### STAFF RECOMMENDATION 1228 4<sup>TH</sup> Avenue North November 20, 2019

**Application:** Preliminary SP Review—Infill  
**District:** Germantown Historic Preservation Zoning Overlay  
**Council District:** 19  
**Map and Parcel Number:** 08209032200  
**Zoning:** IR (existing); SP (proposed)  
**Applicant:** Brian Haun, Allard Ward Architects  
**Project Lead:** Melissa Baldock, melissa.baldock@nashville.gov

Preliminary SP Plan  
 A New Development at:  
**4th and Monroe**  
 1228 4th Ave N.  
 Nashville, Tennessee 37208

Figure 1. 1228 4<sup>th</sup> Avenue North

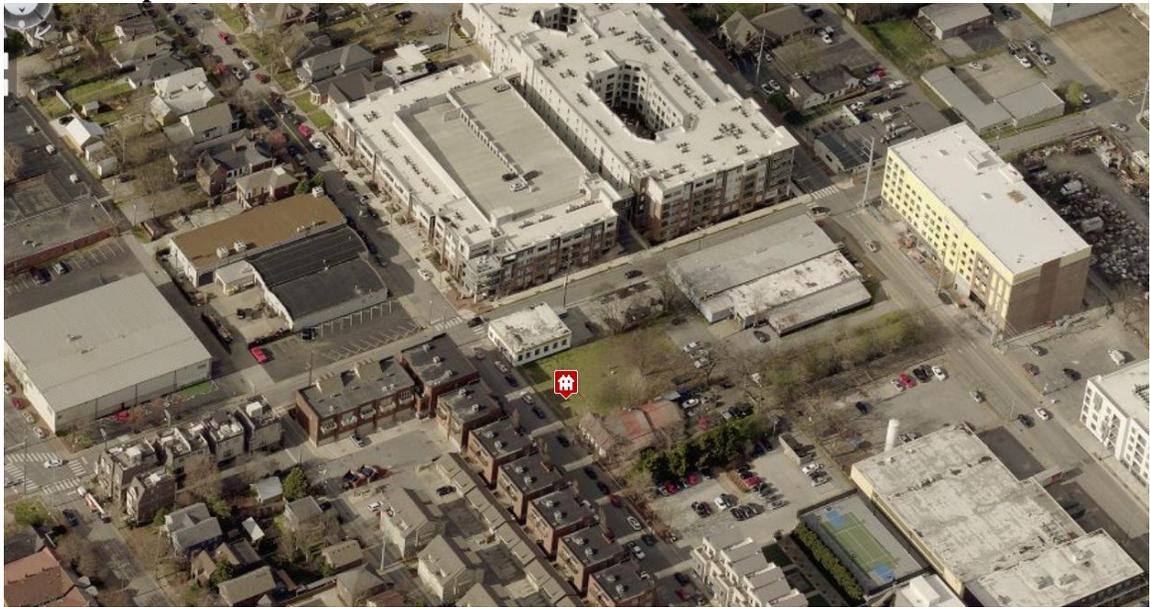
**Background:** 1228 4<sup>th</sup> Avenue North is a vacant lot in the East Development Zone of the Germantown Historic Preservation Zoning Overlay (Figure 1). The lot is approximately ninety feet wide and one hundred and eighty feet deep (90' X 180').

Ⓐ Front Units: West Elevation  
1/8" = 1'-0"

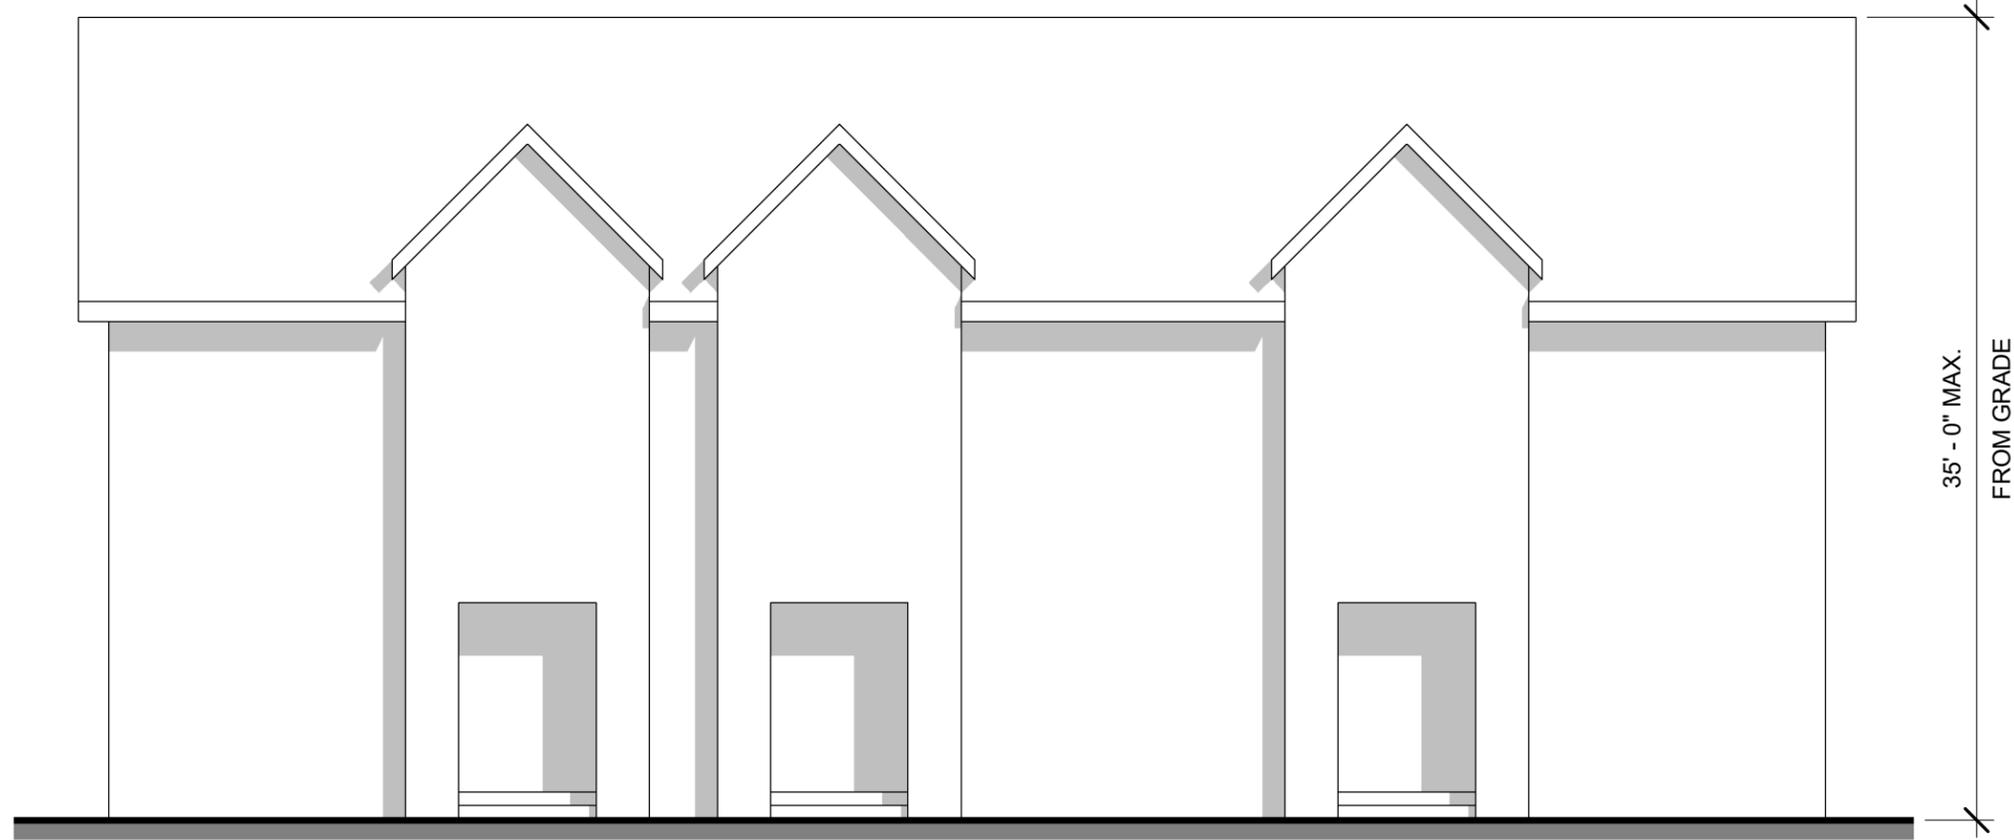
**Height and Scale:** The townhouses along 4<sup>th</sup> Avenue North will be two-stories with a maximum ridge height of thirty-five feet (35') at the front from grade. The eave height will be approximately twenty-one feet, six inches (21'6") above the grade. The structure will be seventy-five feet (75') wide along 4<sup>th</sup> Avenue North and approximately forty-eight feet (48') deep. The height and number of stories meets the maximum allowed by the design guidelines and is similar or less than the immediate context which includes a one-story historic building to the right. This area of low historic context also includes three-story townhomes directly across the street and one lot down at the corner of Monroe St and 4<sup>th</sup> Ave N.

Roof Form: The townhouses that face 4<sup>th</sup> Avenue North will have a double side gable roof form with a 10/12 slope. The front of the townhouses will have a gabled two-story bay that projects two feet (2') from the line of the building. The rear of the townhouses will have shed dormers that are inset two feet (2') from the wall below. Staff finds this roof form to be appropriate.

**E** Front Unit Garages: West Elevation  
 1/8" = 1'-0"

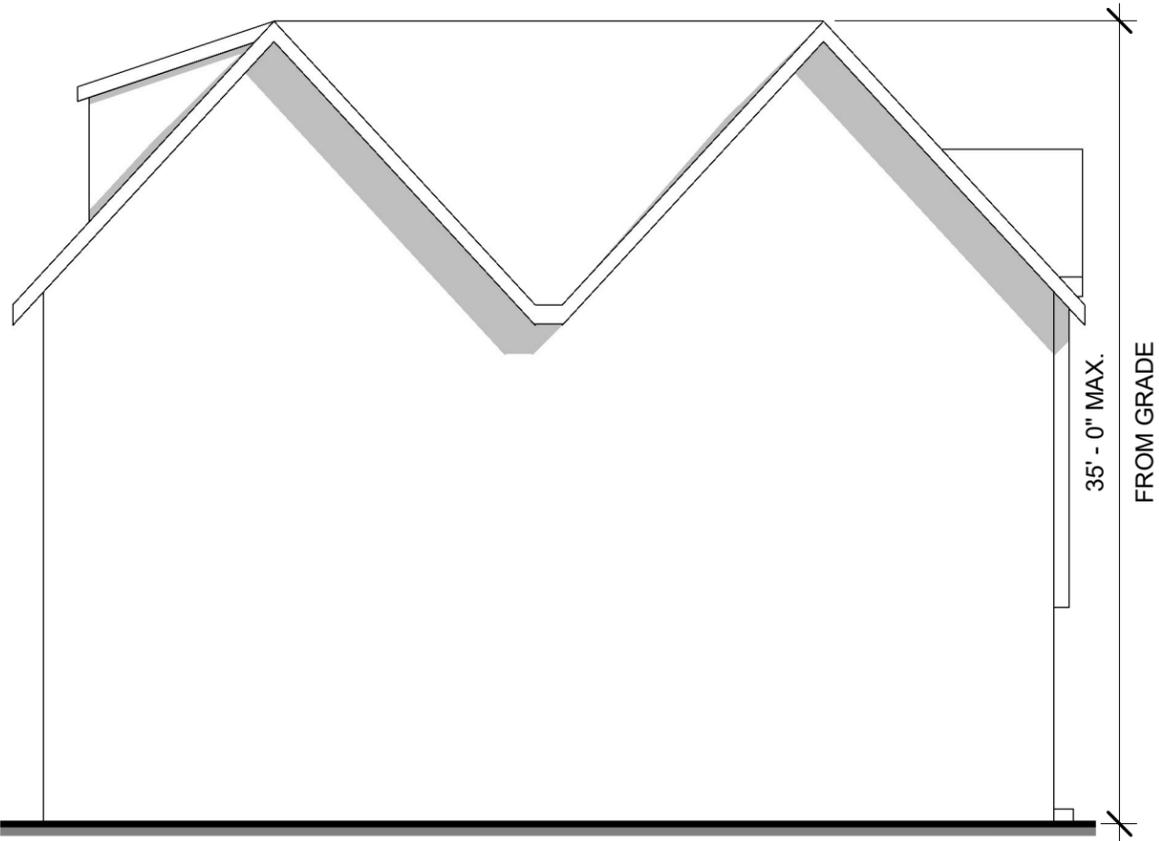
The garage structure in the middle of the townhouses will be one story, with a maximum height of nineteen feet, eight inches (19'8") from grade. It will be twenty-two feet deep and seventy-five feet wide (22' X 75'). Staff finds that this height and scale meet the design guidelines.

The middle garage building will have a roof form that is partially gabled and partially flat. The design guidelines state that rooftop decks may be appropriate in the East Development zone of Germantown. Staff recommends that the applicant return to the Commission with the details of any rooftop deck to ensure that it meets Section III.E.9. of the design guidelines.

**J** Rear Units: East Elevation  
1/8" = 1'-0"

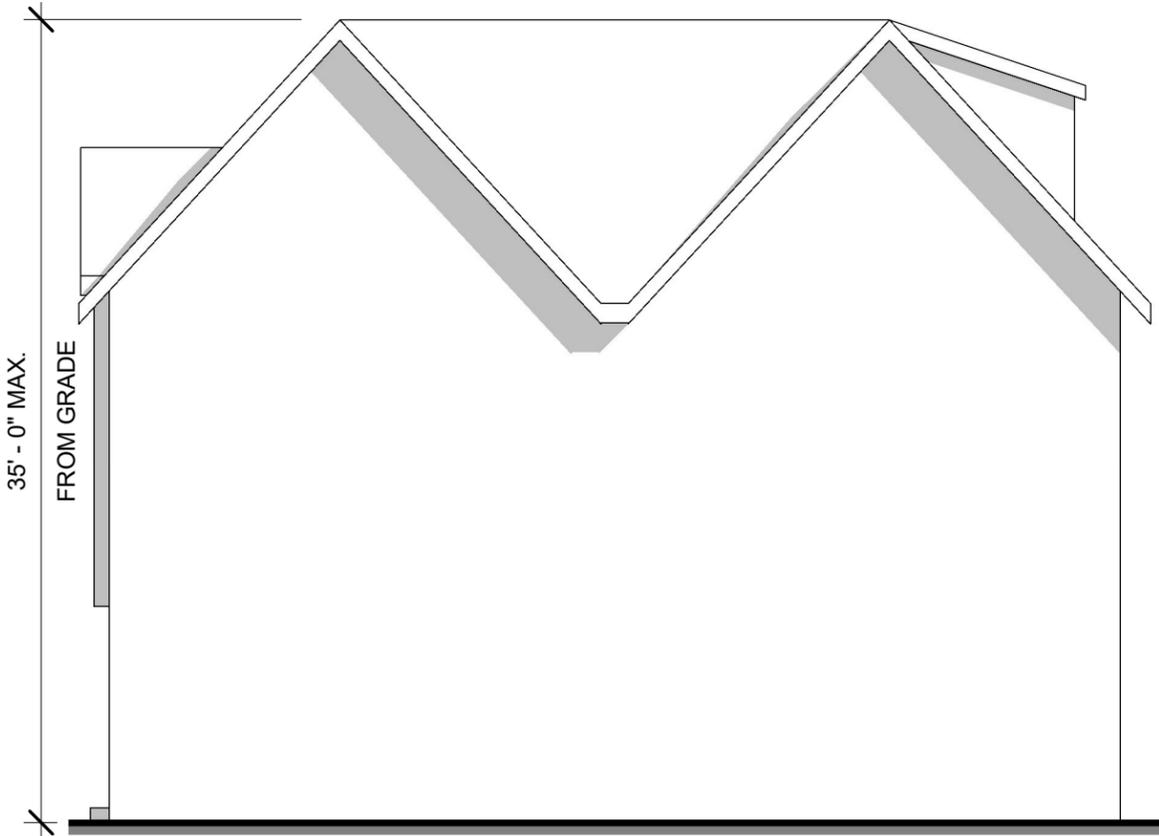
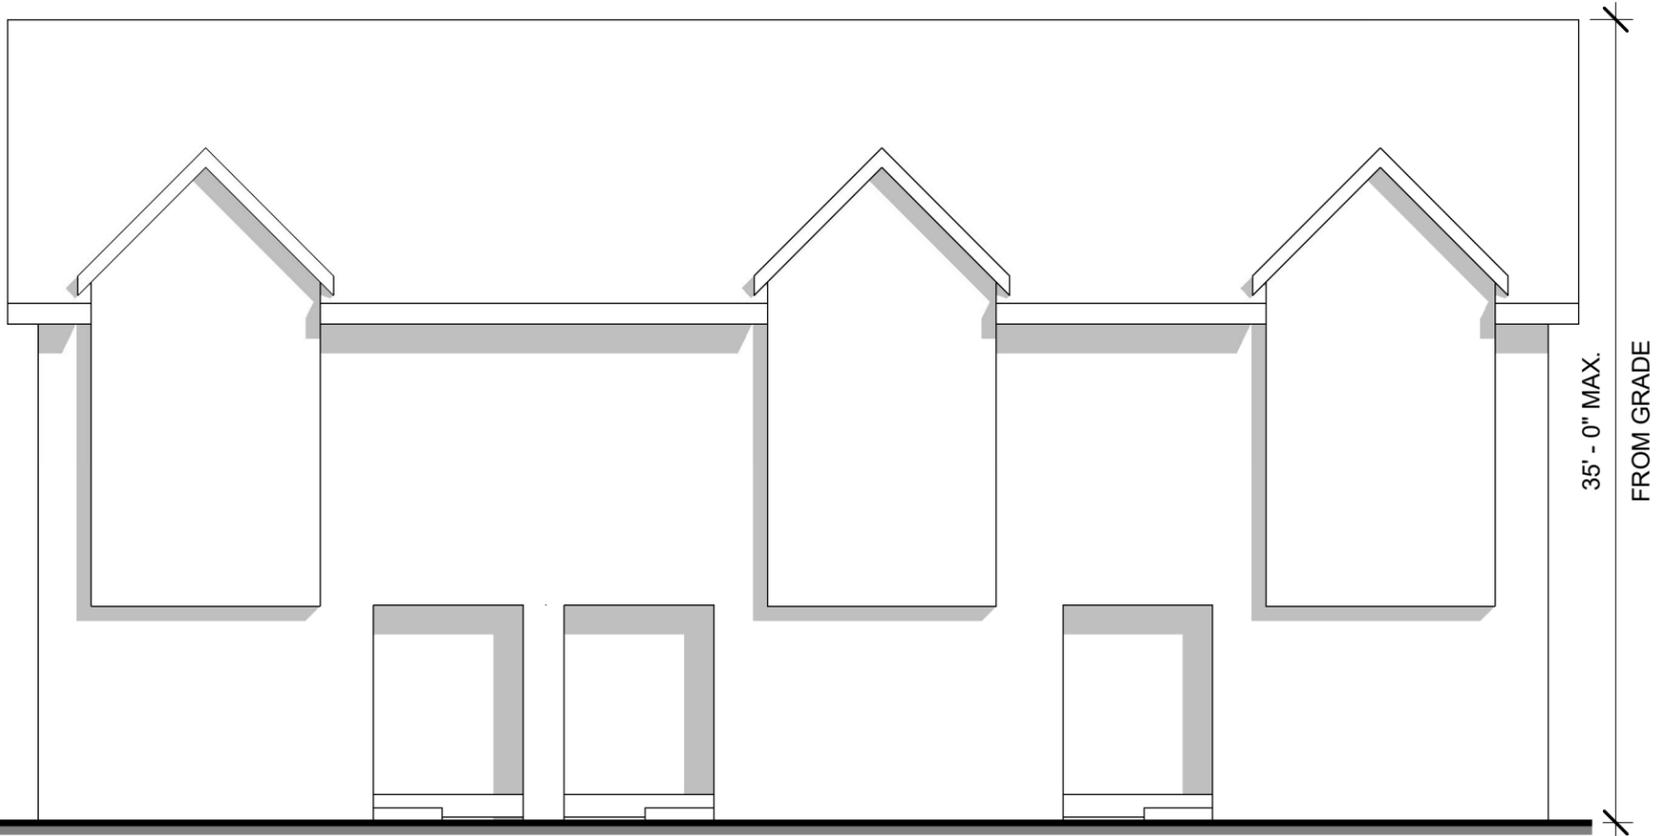
The townhouses at the rear will have the same ridge and eave heights as the 4<sup>th</sup> Avenue North townhouses. However, their footprint will be slightly smaller; they will be sixty-six feet wide (66') in total and approximately forty-four feet, two inches (44'2") deep. Although rear buildings should generally be subordinate to the primary street-facing buildings, this is an area of low historic-context where dense developments have been found to be appropriate. Staff finds that the two-story townhouses along 4<sup>th</sup> Avenue North and along the alley meet the design guidelines.

The rear townhouses at the alley will have similar roof forms to those townhouses along 4<sup>th</sup> Avenue North, with the exception that the projecting gable bays on the alley elevation that do not extend all the way to the ground.
